Before the FEDERAL COMMUNICATIONS COMMISSION Washington, DC 20554

In the Matter of
Telesat Canada
Petition for Declaratory Ruling

File No. SAT-PDR-20161115-00108

REPLY COMMENTS OF WORLDVU SATELLITES LIMITED

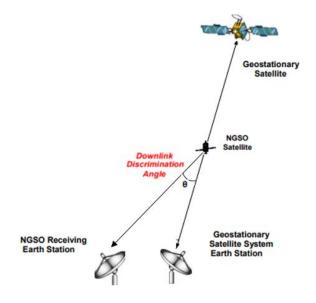
Telesat claims it "will meet the worst-case epfd limit 100 percent of the time" by employing a large exclusion angle, such that the worst-case EPFD limits are not exceeded at Telesat's projected peak downlink e.i.r.p. densities.³ Telesat provides the below diagram as an illustration:⁴

As OneWeb has previously pointed out,⁵ this analysis is insufficient because it neglects

one of the most critical in-line geometry cases - one where the NGSO satellite is directly in-line

between the GSO satellite and its associated receiving earth station (illustrated below). Telesat failed to analyze this case in its application.⁶

In the interference scenario shown above, the only protection afforded the GSO receiving earth station is the off-axis rejection of the NGSO satellite transmit antenna, represented by the off-axis angle θ , because in this example the earth station receive gain discrimination is zero, since the ϕ angle is nil.

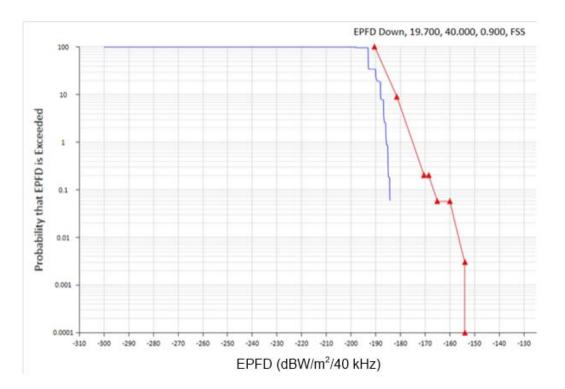
Furthermore, Telesat provides EPFD results in its latest pleading that contradict its assertion that it will meet the worst-case EPFD limit 100 percent of the time. In its original application, Telesat claimed that it was not necessary for it to perform a thorough EPFD_{down} analysis because its GSO exclusion was large enough to ensure that its maximum EPFD_{down} level would not exceed -190.4 dBW/m²/40 kHz.¹⁰ This is clearly not the case, as shown by the latest Telesat EPFD plot (reproduced below).¹¹ In this plot it is clear that there are some EPFD values

exceeding -185 dBW/m²/40 kHz, which is significantly higher than the worst-case EPFD limit of -190.4 dBW/m²/40 kHz in the 19.7-20.2 GHz frequency band.¹²
